AGENDA
Cascade Charter Township Planning Commission
Monday, February 06, 2017
7:00 pm
Cascade Library Wisner Center
2870 Jacksmith Ave. SE

TO: Cascade Charter Township Planning Commission
FROM: Steve Peterson, Community Development Director
REPORT DATE: January 19, 2017
MEETING DATE: February 6, 2017
CASE: #16-3348 – Edward Rose/Meadowbrooke PUD Amendment

Re: Garden Apartments
Site Plan Review

Figure 1

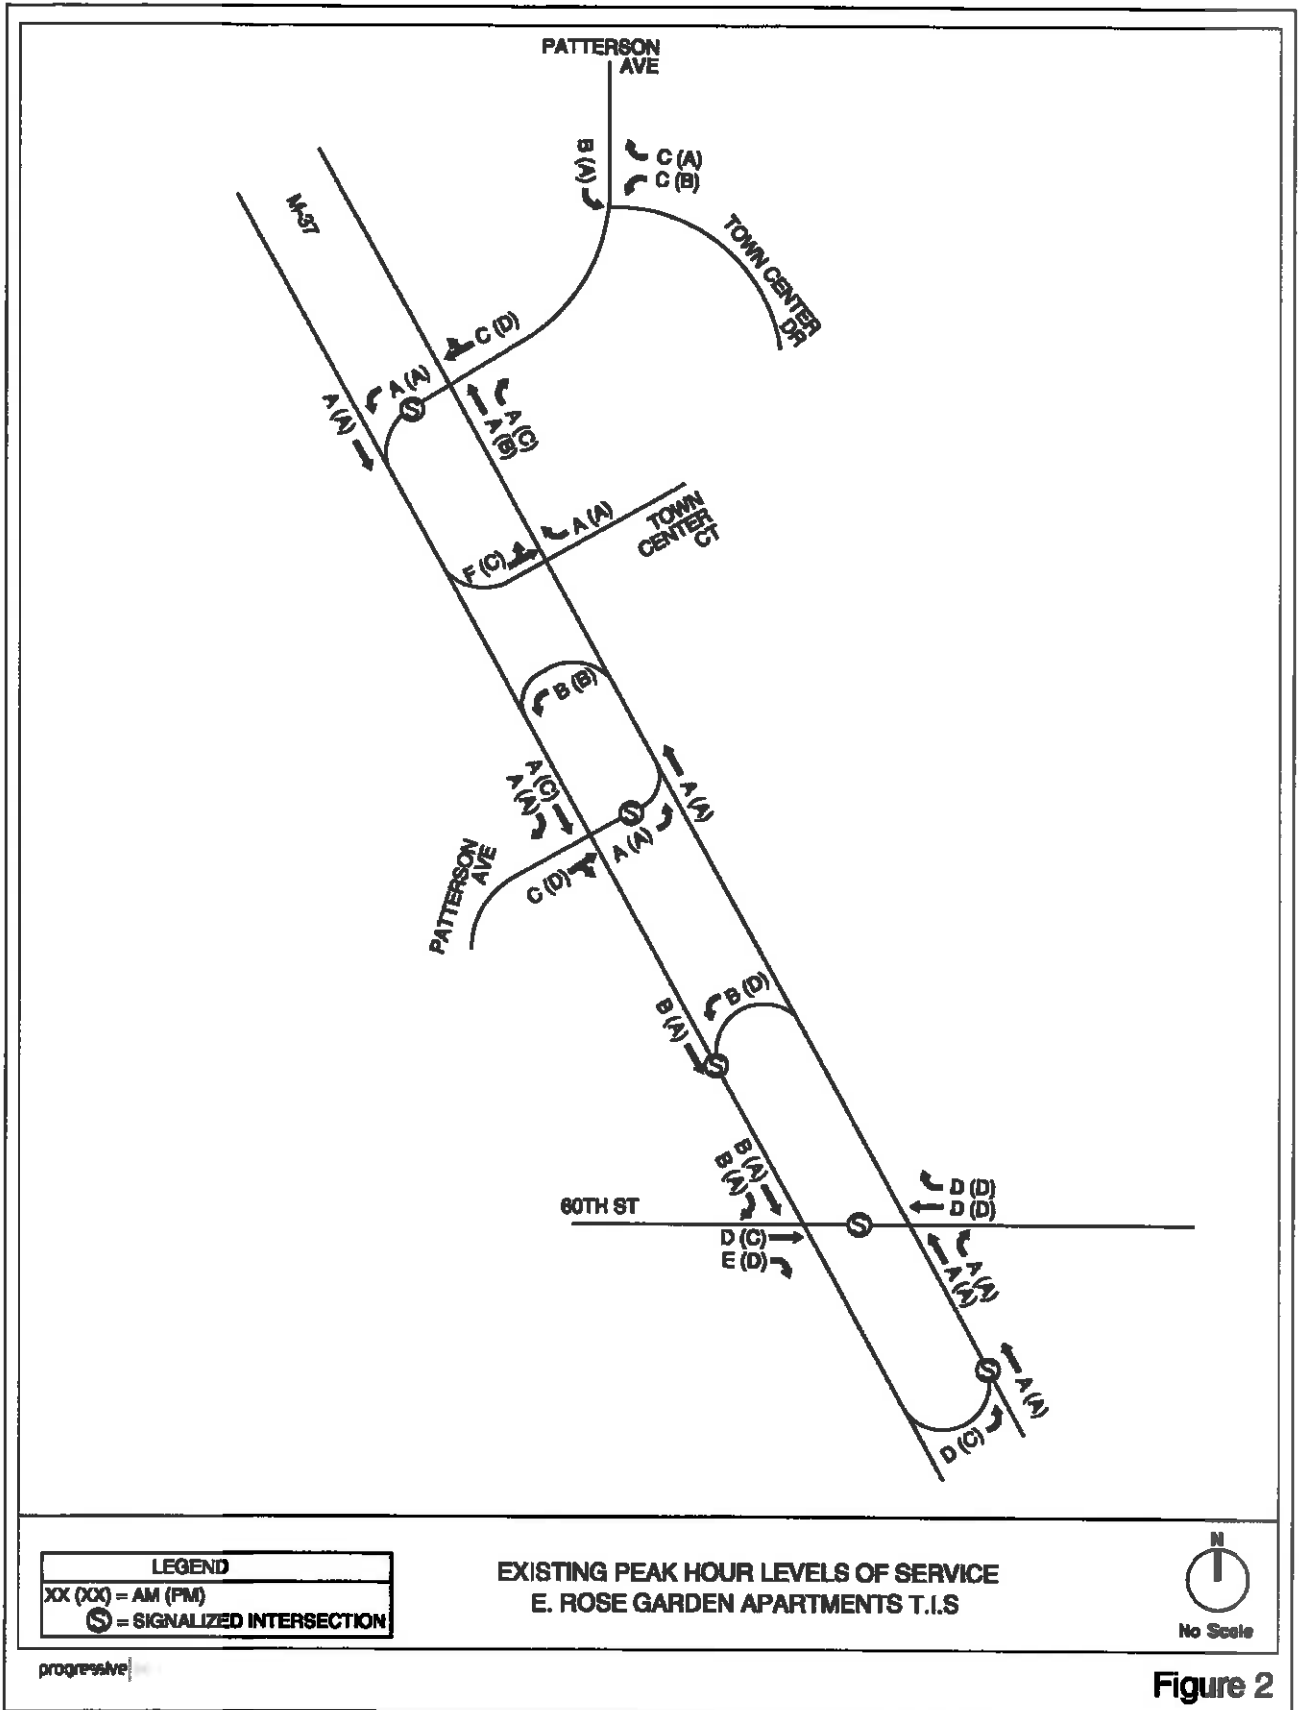
The existing peak hours were analyzed at the study area intersections. The results of the level of service analyses are shown on Figure 2. Copies of the computer analyses are included in the appendix.

As shown, it appears that almost all of the constrained movements at the study area intersections operate acceptably during both peak hours. The apparent exceptions occur at the crossover from southbound M-37 into Town Center Court during the morning peak hour, and the eastbound right turn on 60th Street at M-37. Neither of these are seen as significant, either due to very small traffic volumes or traffic model anomalies.

One key problem area shows up at the M-37/Patterson (north) intersection during the afternoon peak hour, even with the indicated LoS is at D. The calculations also show that the volume-to-capacity ratio (v/c) for the southbound through/left turn onto M-37 is 1.01, typically resulting in an LoS F if the current capacity manual software were applicable. That potential congestion indication is backed up by subsequent simulations that show significant southbound queuing problems on Patterson for most of the peak hour. On-site observations to date confirm that queuing problem.

Given the results of the Existing Conditions analysis and related traffic simulations, indications are that MDOT and the KCRC should consider modifications to the M-37/Patterson (north) intersection. Such modifications will be further discussed in the following Background Conditions chapter.

Figure 3

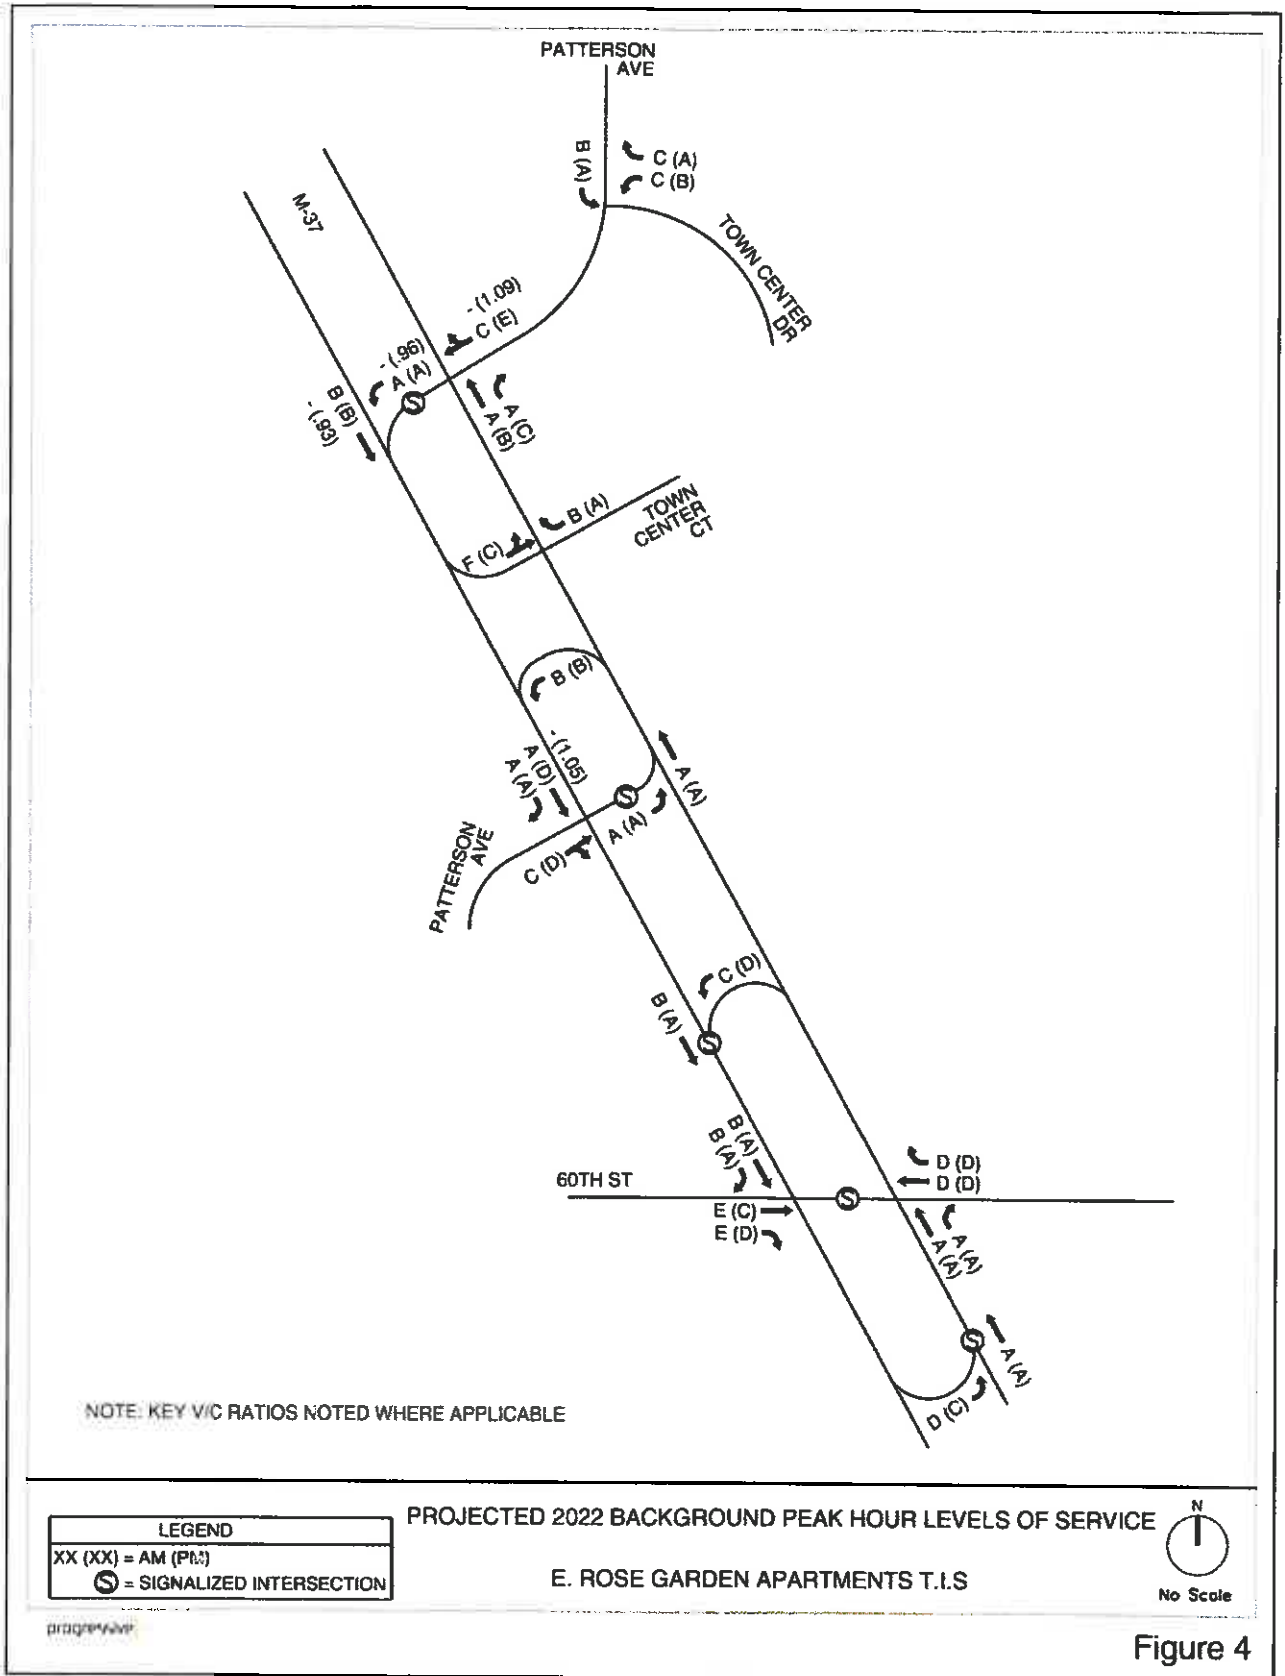
As shown, most all of the constrained movements at the study area intersections are expected to continue to operate acceptably during both peak hours. The exceptions are the same as noted under the Existing Conditions summary, plus the southbound Patterson approach to M-37 is expected to degrade to a level of service E during the afternoon peak hour. That poor level of service (or worse) is confirmed for that movement by its v/c ratio of 1.09 and model simulations that continue to show very lengthy queues (1/4 mile+) for much of the afternoon peak hour.

To alleviate the southbound Patterson (northern section) congestion, several iterations/alternatives to provide that movement with a few more seconds of green time were tested, but resulted in degrading the southbound M-37 movement at that intersection to unacceptable v/c's and related queuing issues – essentially just shifting the problem to M-37.

However, there doesn't appear to be any viable physical improvements that can be added to Patterson Avenue at the intersection to improve the current and projected congestion. Therefore, based upon the above findings, and those outlined in the Existing Conditions chapter, it appears that MDOT and KCRC should consider widening southbound M-37 to three lanes from just north of its northern intersection with Patterson Avenue down to where it already has a three-lane cross section just south of its southern intersection with Patterson Avenue, a distance of approximately 1,900 feet. Such a cross section would match the three-lane section on the northbound side of M-37 in this subarea, likely completed in the past due to the same "hourglass" issue.

Capacity calculations were completed to evaluate the effect of that improvement (along with related and other signal operation changes) for both peak hour 2022 background conditions at the study area intersections. The results of those calculations and subsequent model simulations show that all the existing and projected deficient levels of service, v/c ratios, and lengthy queues are mitigated to acceptable levels for both peak hours. The one exception is at the northbound M-37/Town Center Court intersection during the morning peak hour, but very low volumes do not warrant additional improvements. Copies of the computer analyses are included in the appendix of this report.

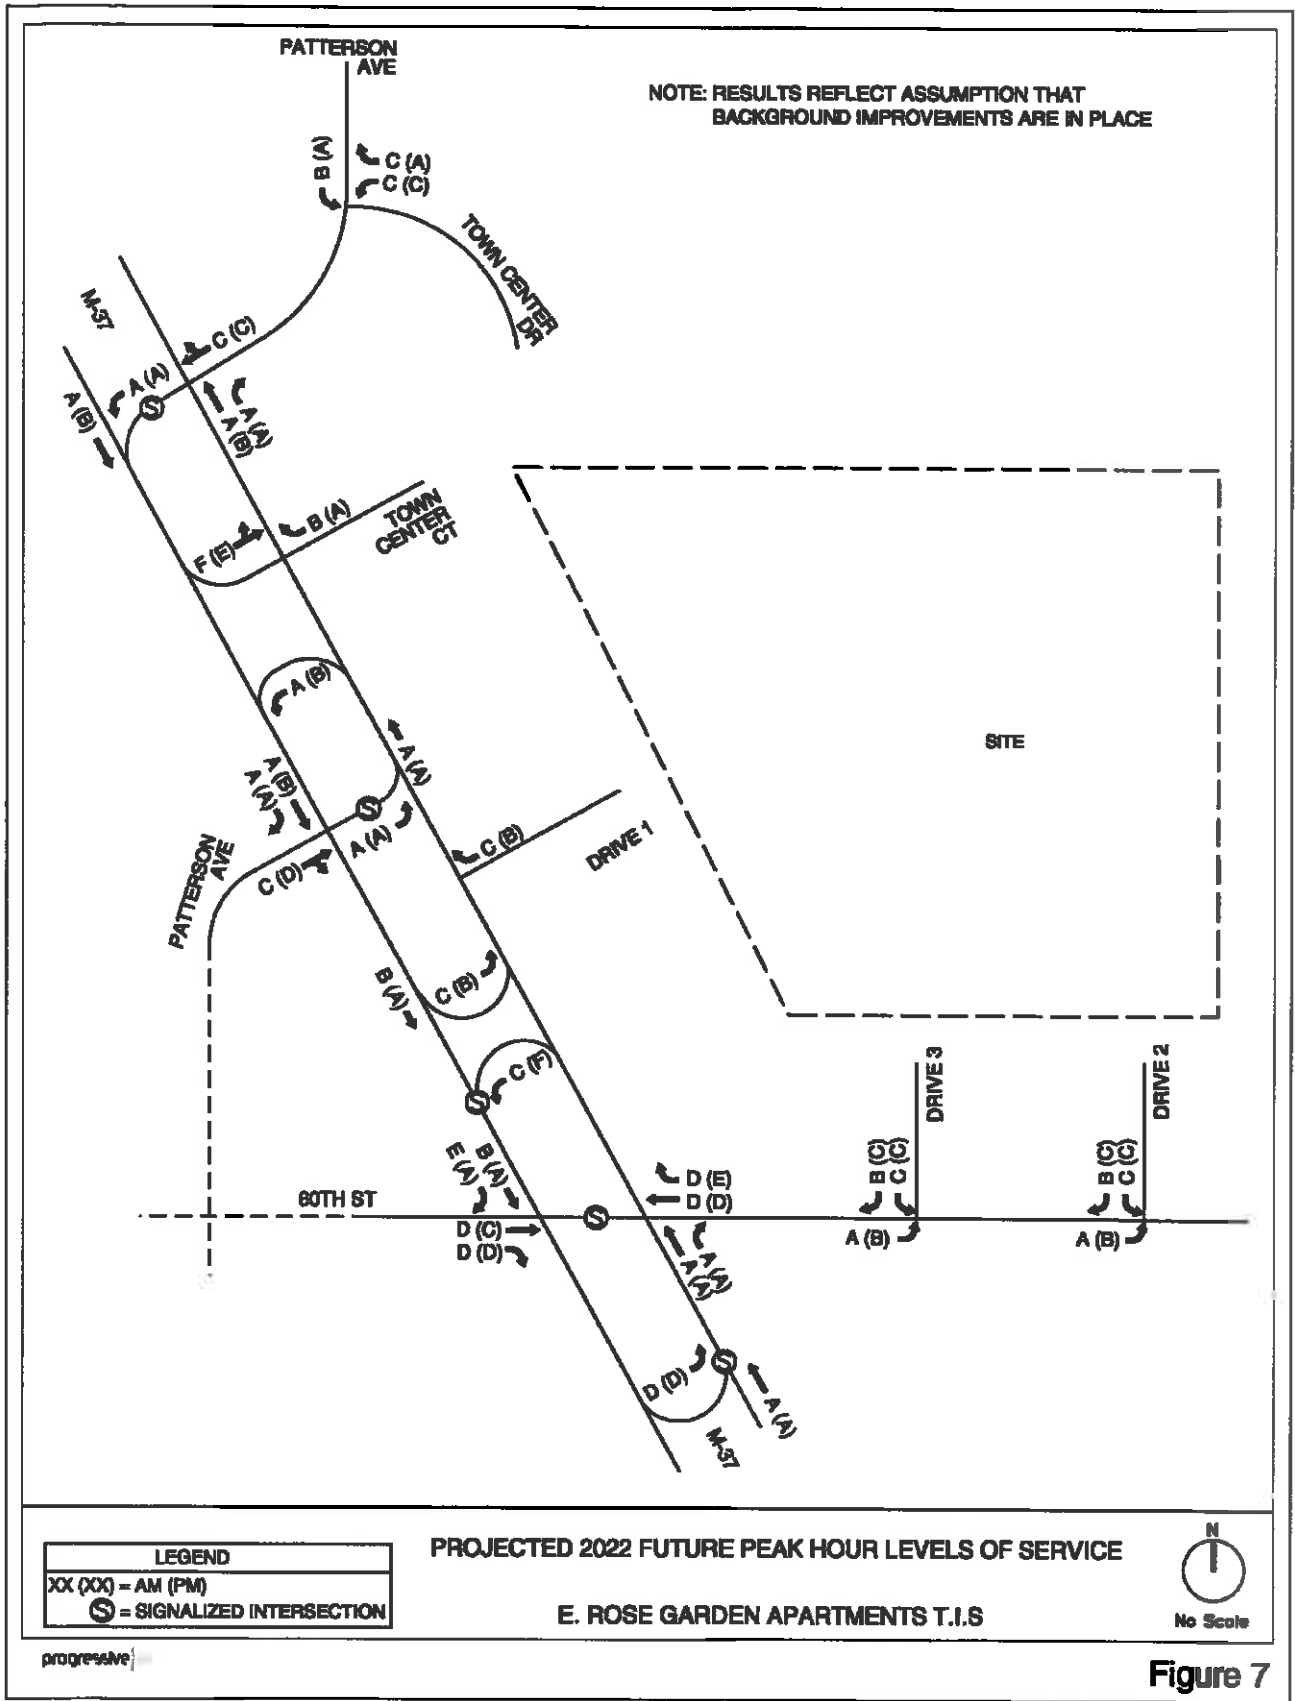
The results of the analyses shown in Figure 7 indicate that with the addition of site generated traffic most of the constrained movements at the study area intersections and site access points will still function acceptably. There are a few exceptions as follows:

- The northbound-to-southbound crossover on M-37 just north of 60th Street is projected to degrade to an LoS F during the afternoon peak hour;
- The westbound dual right turn on 60th at M-37 is projected to degrade to an LoS E during the afternoon peak; and
- The eastbound crossover movement across northbound M-37 into Town Center Court is projected to degrade to an LoS E during the afternoon peak hour.

Although it doesn't show up as an issue from the capacity calculations, subsequent model simulations indicate that there may also be afternoon peak hour congestion on the southbound side of M-37 at the existing dual lane northbound-to-southbound crossover located just south of Town Center Court. In our opinion that is primarily due to the traffic model's assumptions regarding unbalanced lane usage (due to southbound downstream M-37 traffic patterns) and is unlikely to operate that way in actual conditions.

1. Add a second left turn lane to the existing northbound-to-southbound crossover just north of 60th Street and adjust signal operations slightly;
2. Adjust the M-37/60th Street signal operations to provide slightly more green time to the 60th Street approaches during the afternoon peak hour;
3. Monitor the future afternoon operating conditions at the crossover just south of Town Center Court and its intersection with southbound M-37 to see if an improvement is needed/warranted there (such as a new signal with proper progression parameters).

Follow-up calculations and model simulations indicate that the above improvements will mitigate the impacts of project traffic and allow the system to function as well or better than projected 2022 background conditions. The exception once again is the eastbound crossover approach to the unsignalized intersection of northbound M-37 at Town Center Court. However, the model simulations show that the relatively small volumes on that eastbound approach find gaps in the northbound traffic stream such that there will not be a queue of over 3-4 vehicles at any one time. Copies of the computer analyses are included in the appendix of this report.
